**GE Energy
Nuclear**

NEDO-33330
Class I
eDRF 0000-0067-1515
May 2007

LICENSING TOPICAL REPORT

**Advanced Boiling Water Reactor (ABWR)
Hydrogen Recombiner Requirements Elimination**

Figure 2.2.6 Remote Shutdown System

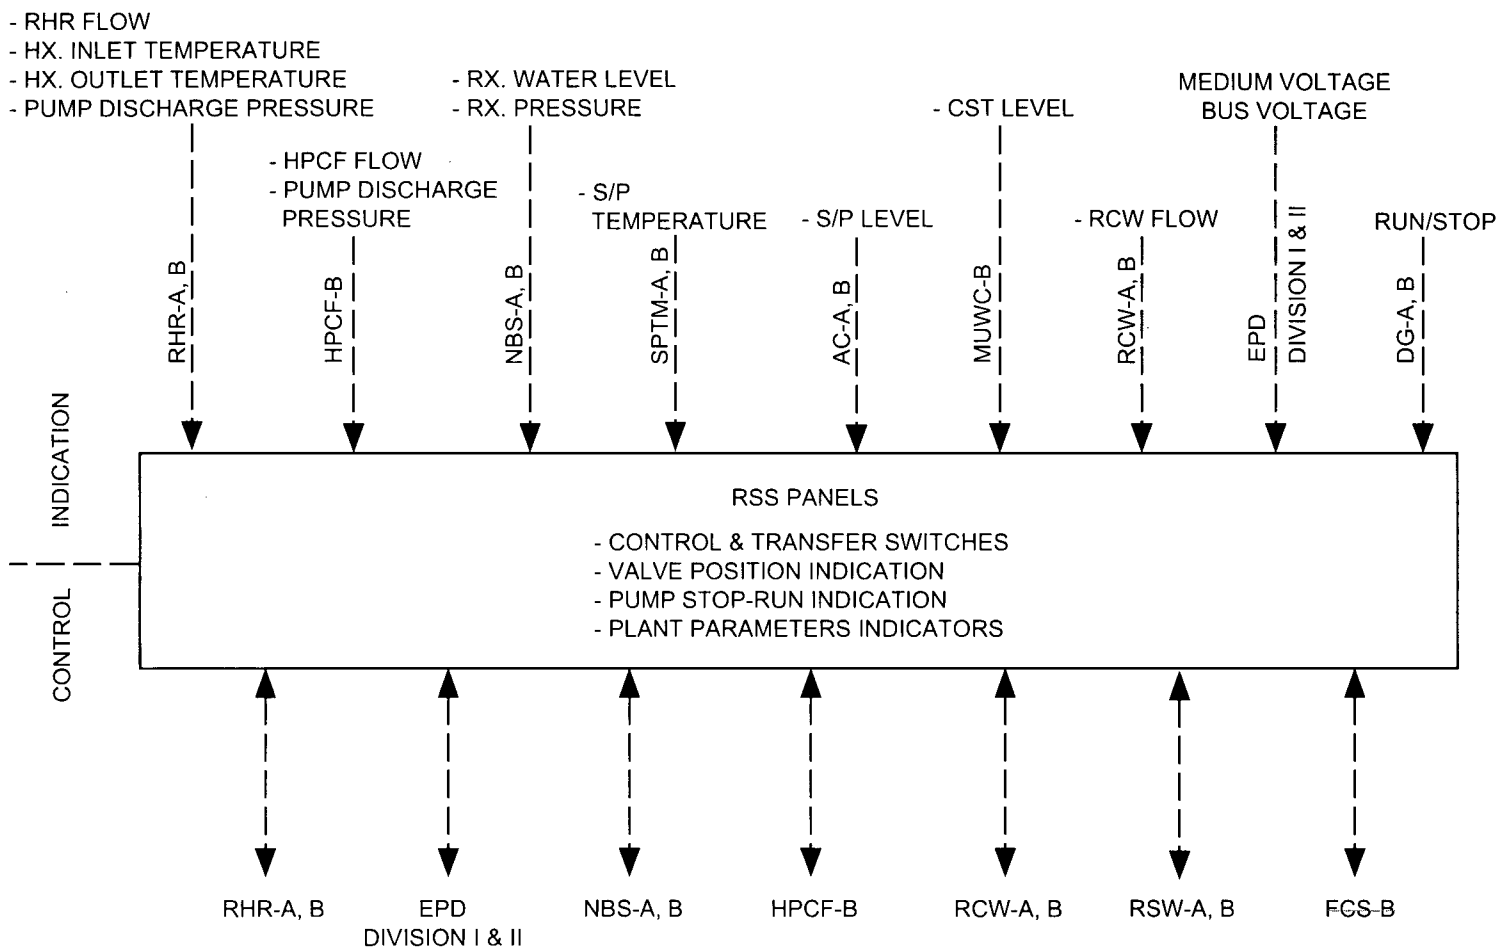
10CFR50.44 was revised on October 16, 2003 to no longer require hydrogen control systems (i.e., Flammability Control System, hydrogen recombiners) for plants with inerted containments.

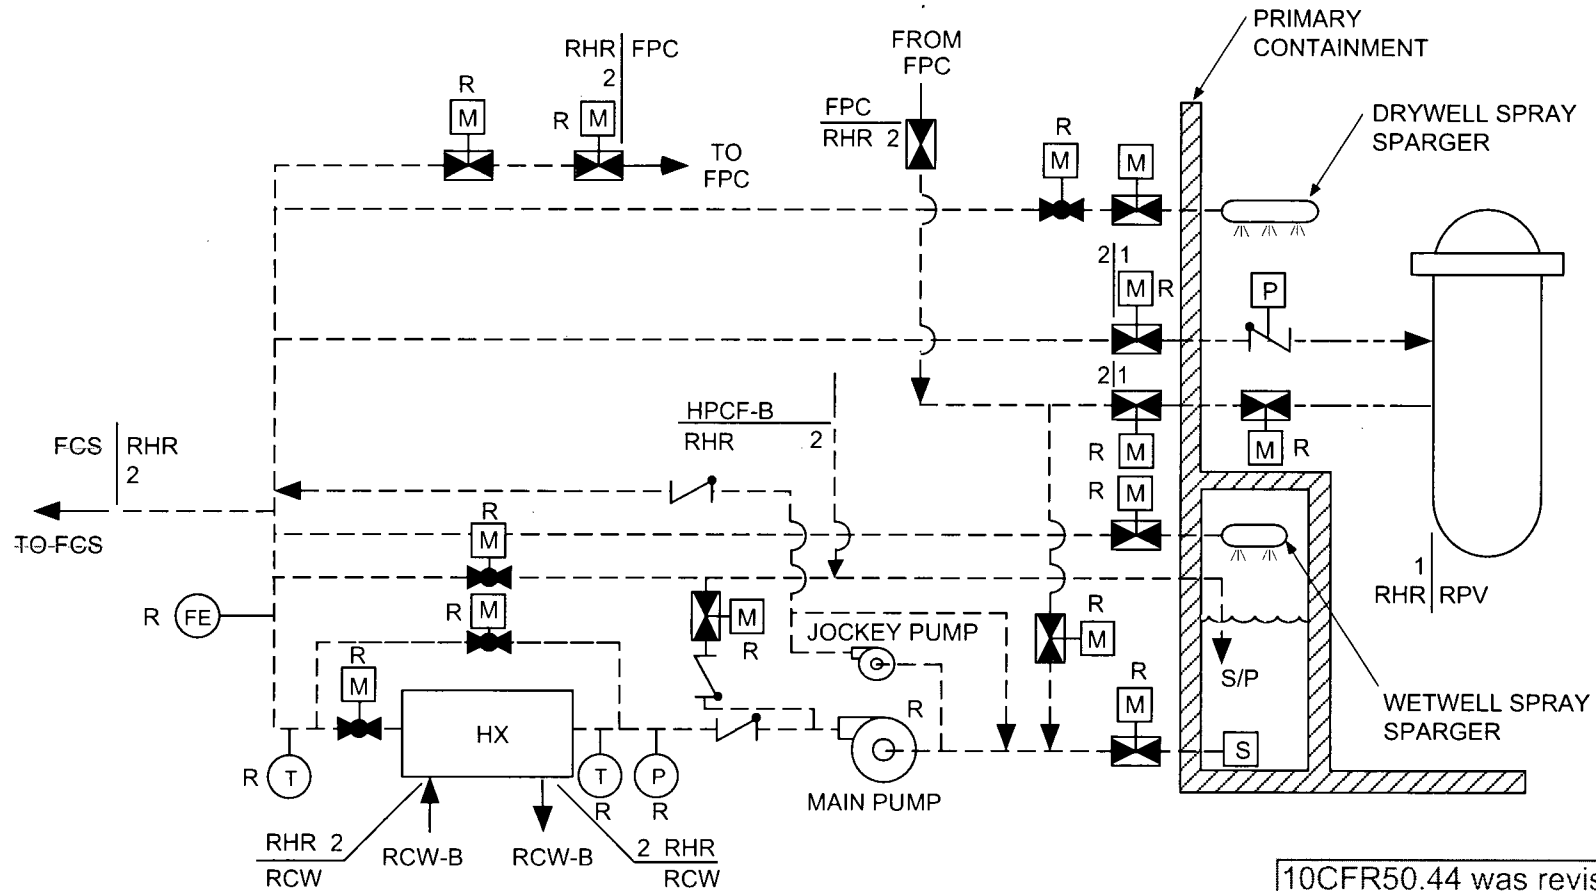
10CFR50.44 was revised on October 16, 2003 to no longer require hydrogen control systems (i.e., Flammability Control System, hydrogen recombiners) for plants with inerted containments.

Figure 2.4.1b Residual Heat Removal System (RHR-B)

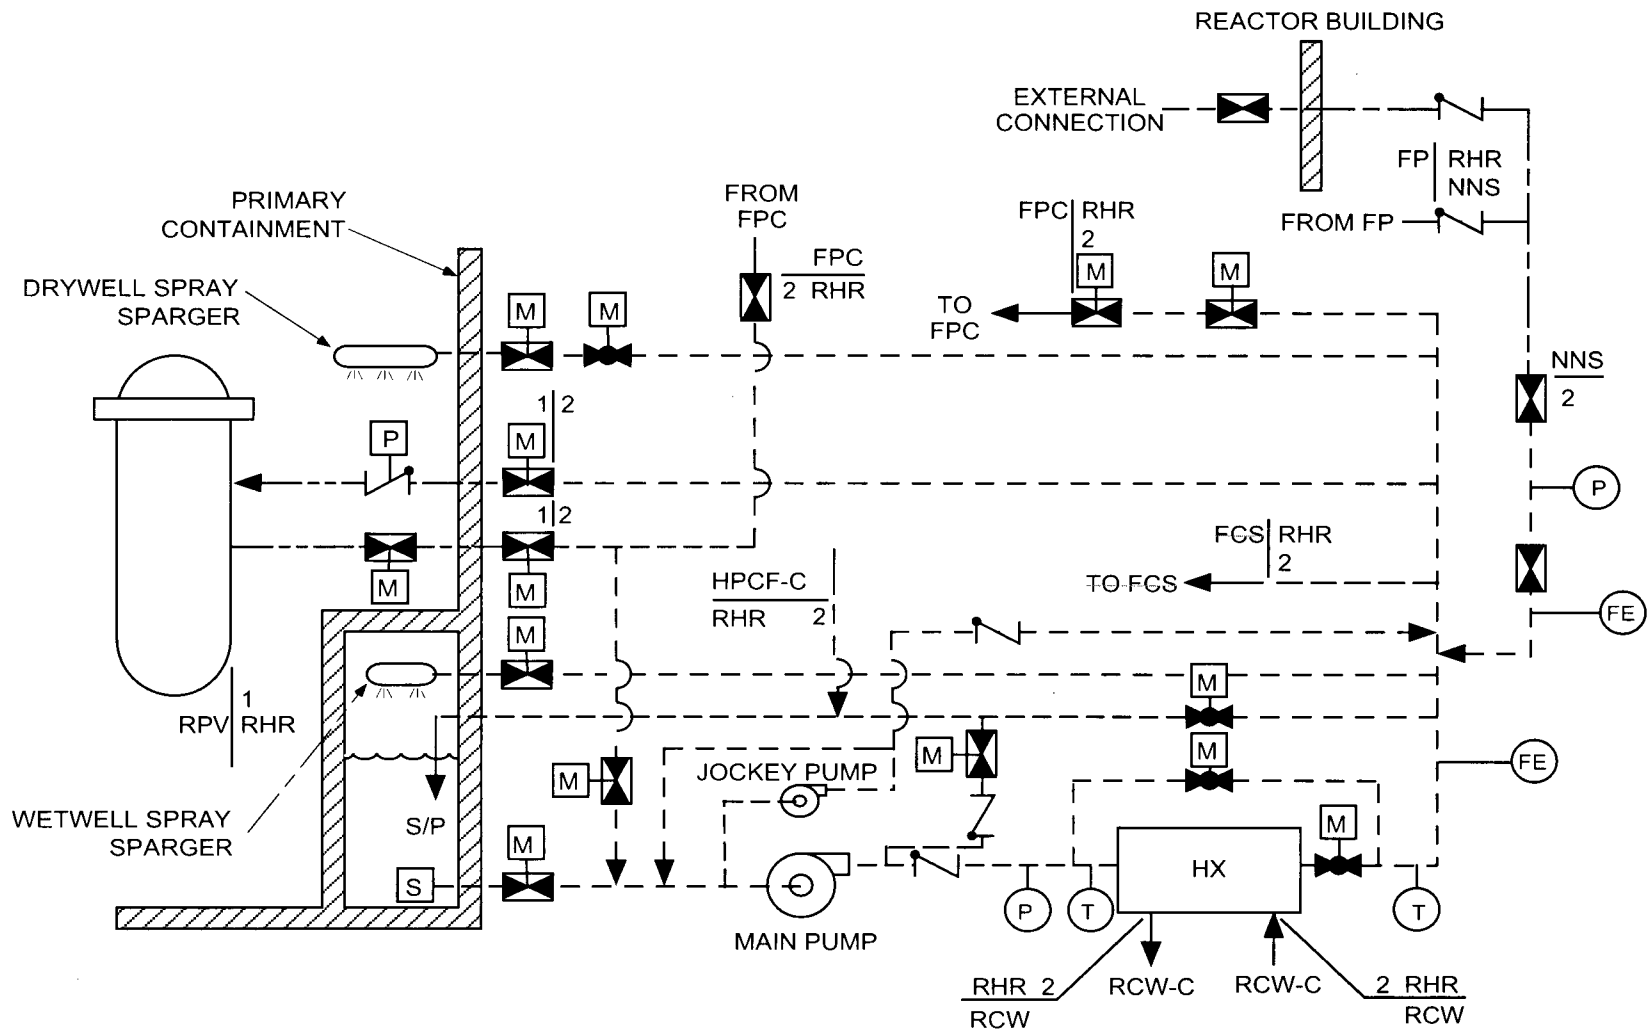
10CFR50.44 was revised on October 16, 2003 to no longer require hydrogen control systems (i.e., Flammability Control System, hydrogen recombiners) for plants with inerted containments.

Figure 2.4.3 Leak Detection and Isolation System Interface Diagram

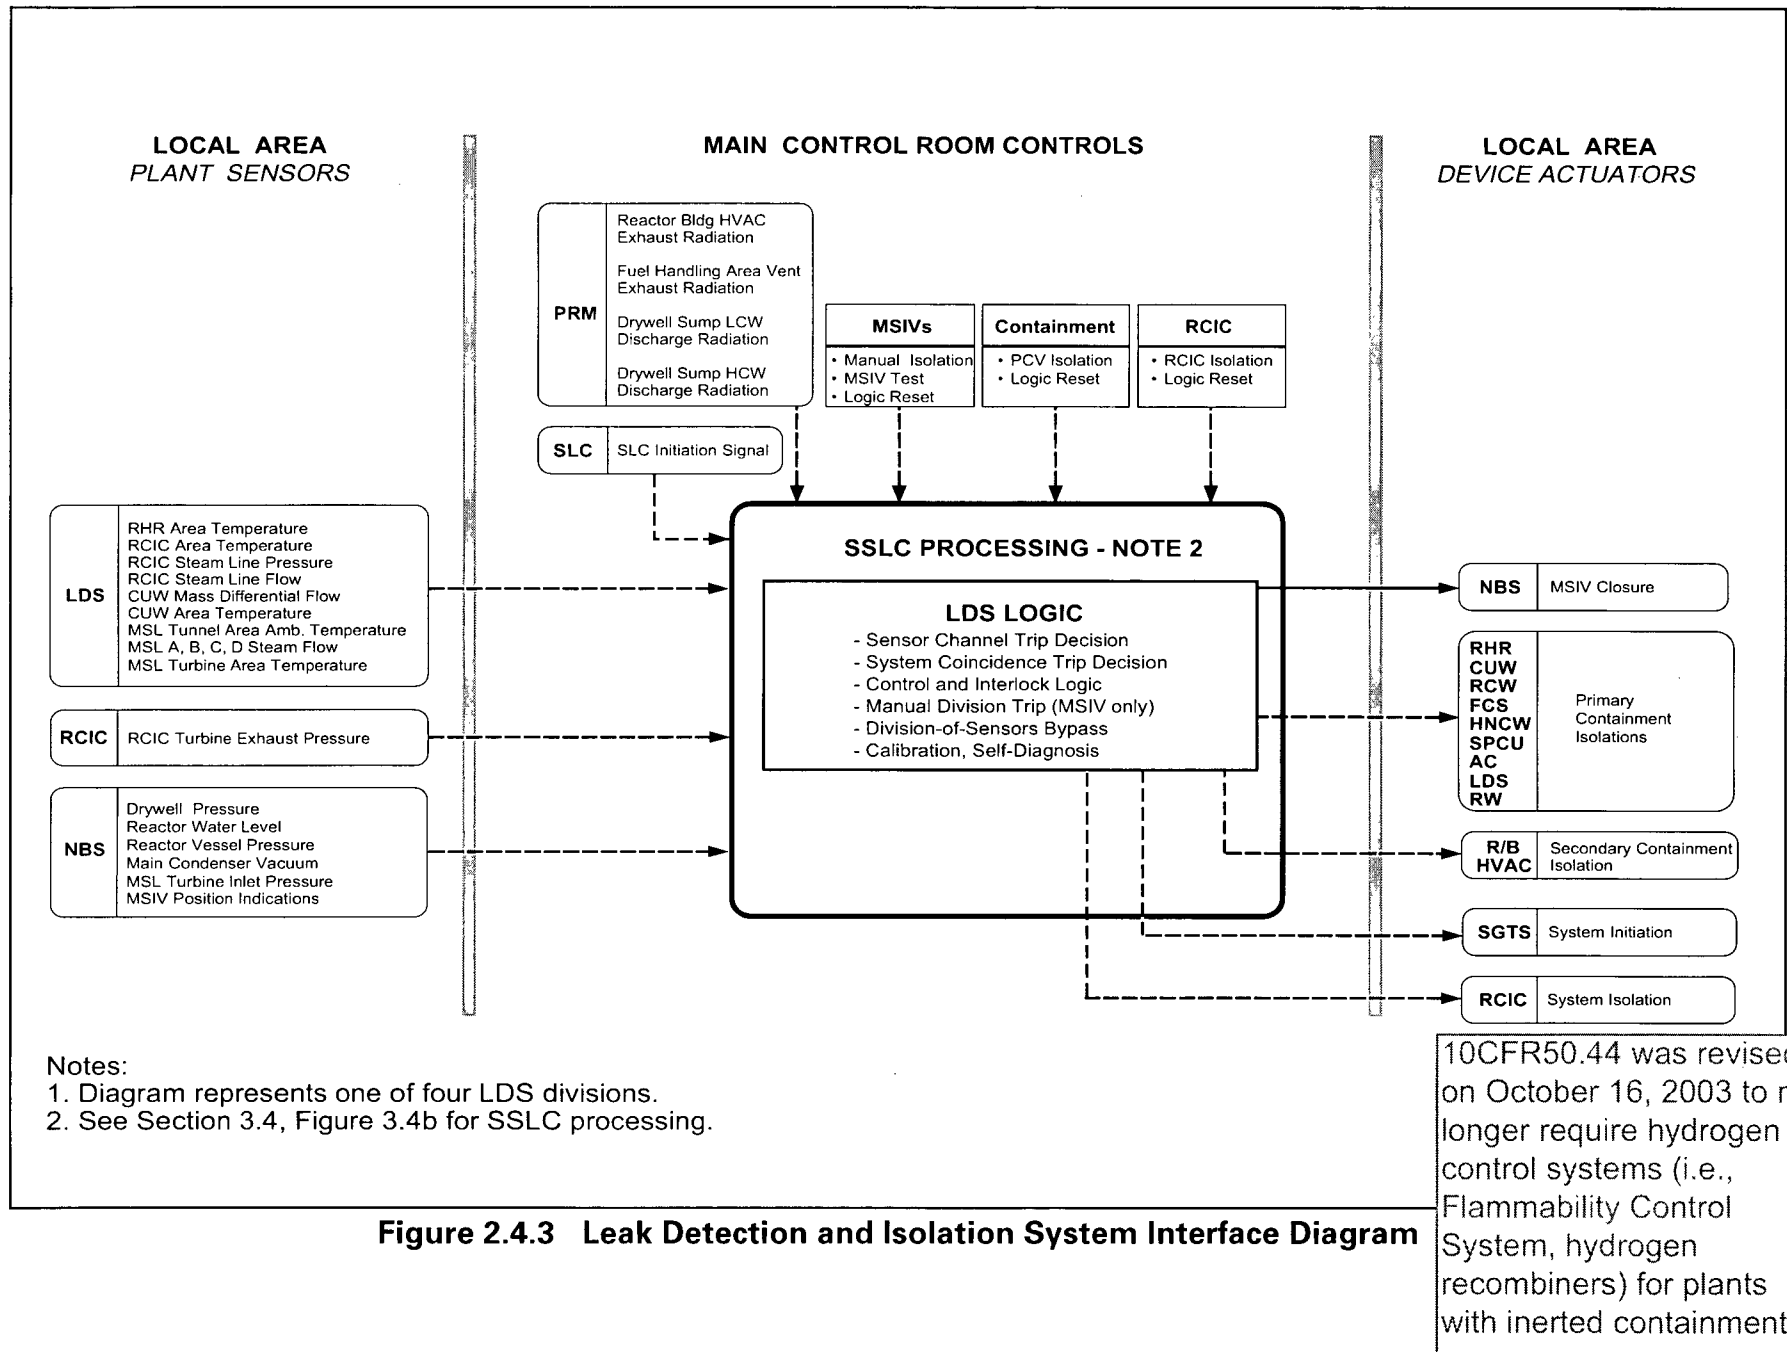
10CFR50.44 was revised on October 16, 2003 to no longer require hydrogen control systems (i.e., Flammability Control System, hydrogen recombiners) for plants with inerted containments.

Figure 2.14.8 Flammability Control System

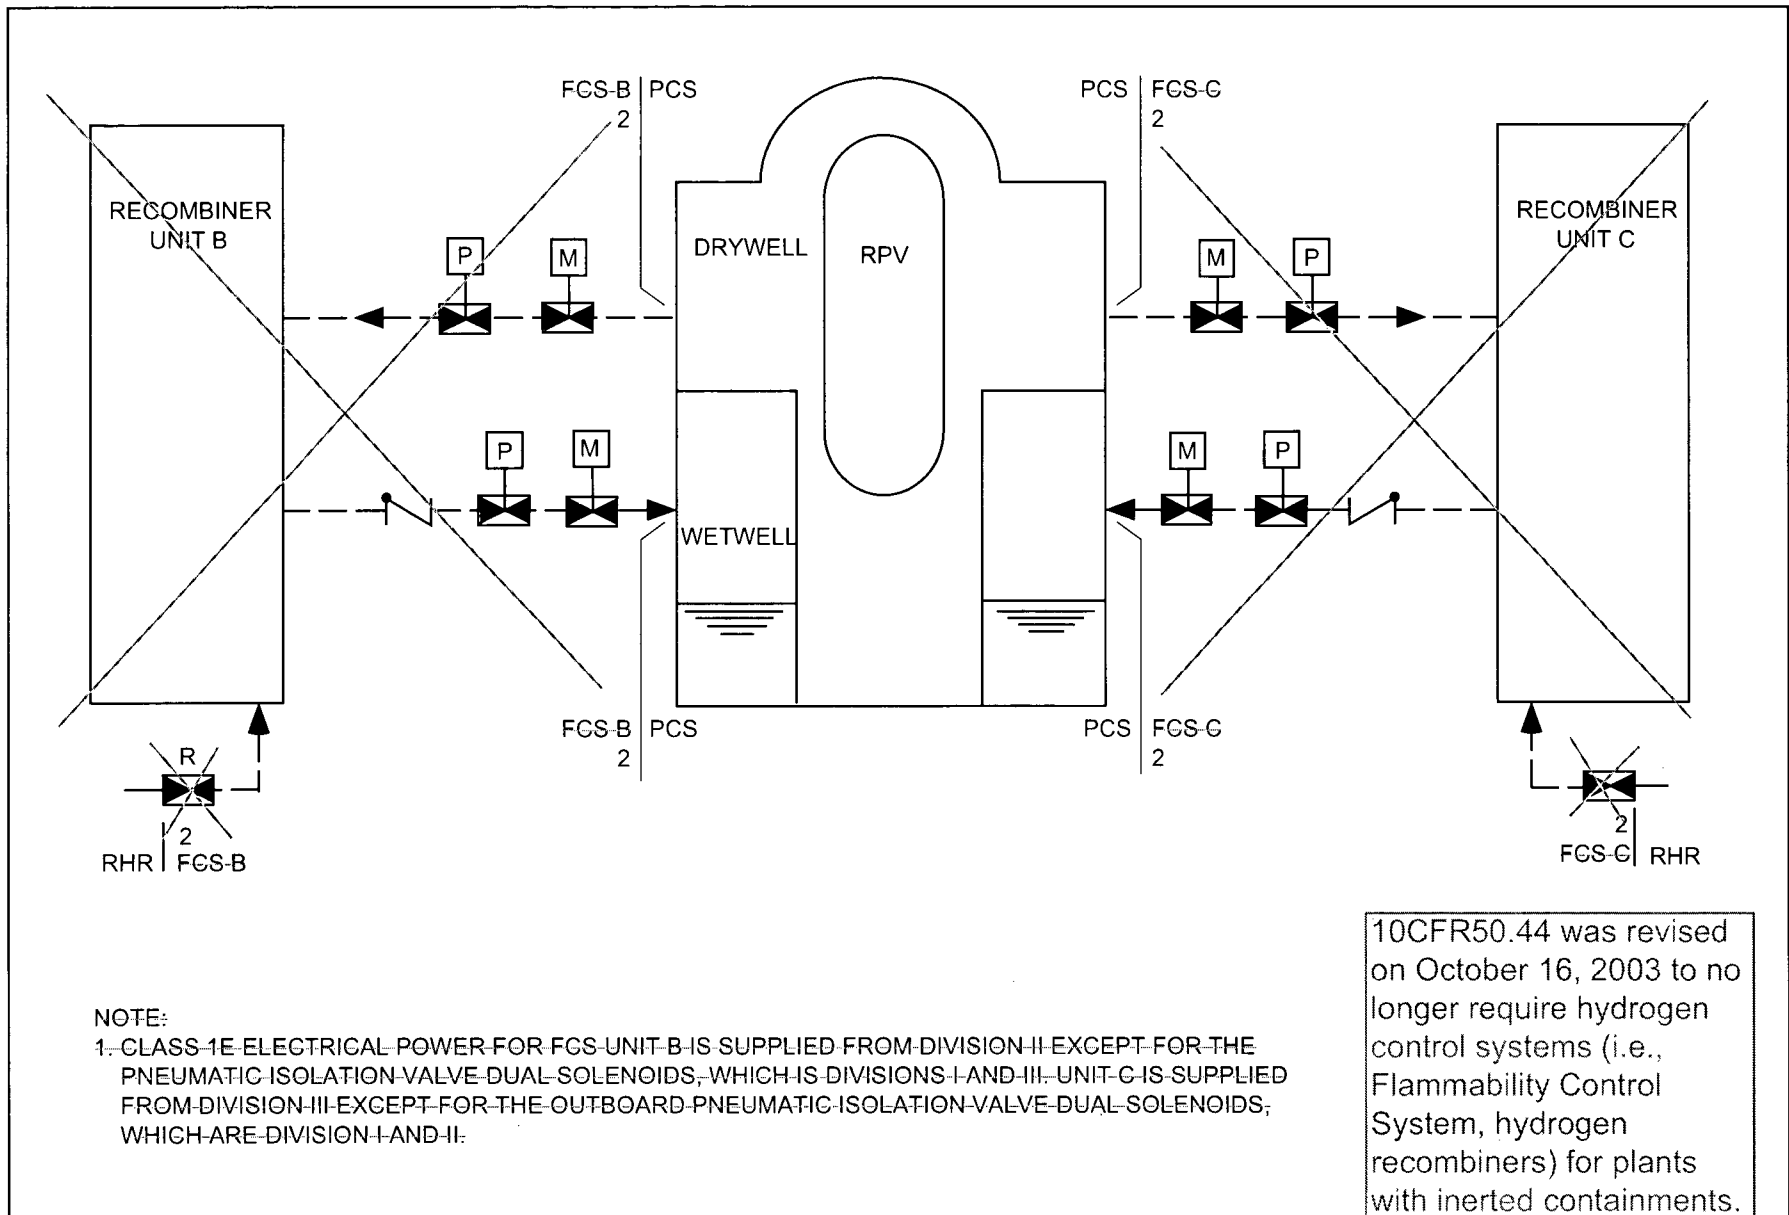
10CFR50.44 was revised on October 16, 2003 to no longer require hydrogen control systems (i.e., Flammability Control System, hydrogen recombiners) for plants with inerted containments.

Figure 2.15.5e Reactor Building Safety-Related Equipment HVAC System

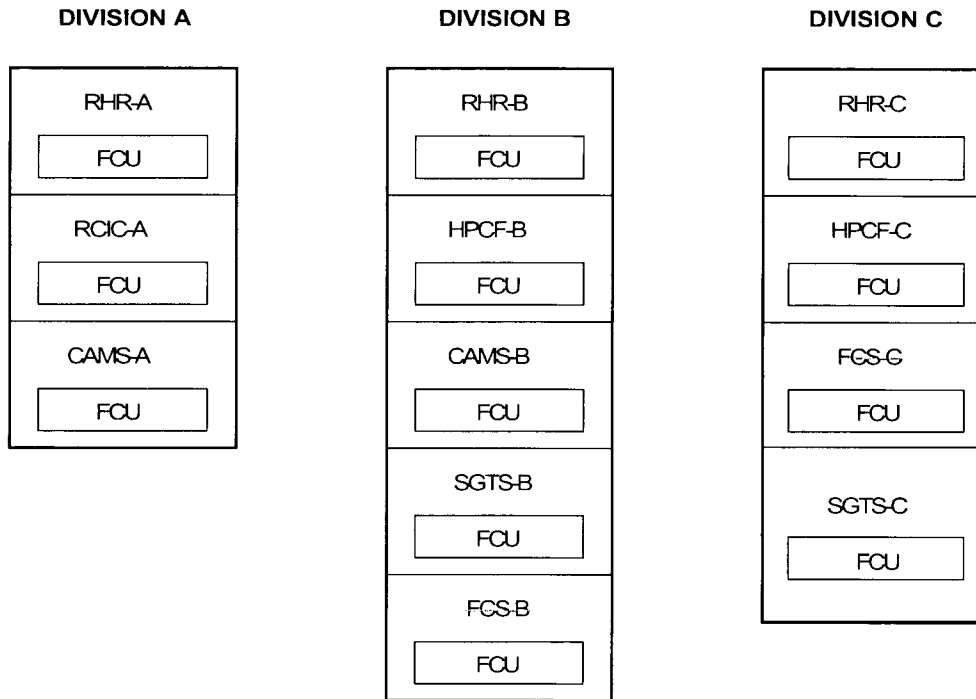
10CFR50.44 was revised on October 16, 2003 to no longer require hydrogen control systems (i.e., Flammability Control System, hydrogen recombiners) for plants with inerted containments.

10CFR50.44 was revised on October 16, 2003 to no longer require hydrogen control systems (i.e., Flammability Control System, hydrogen recombiners) for plants with inerted containments.
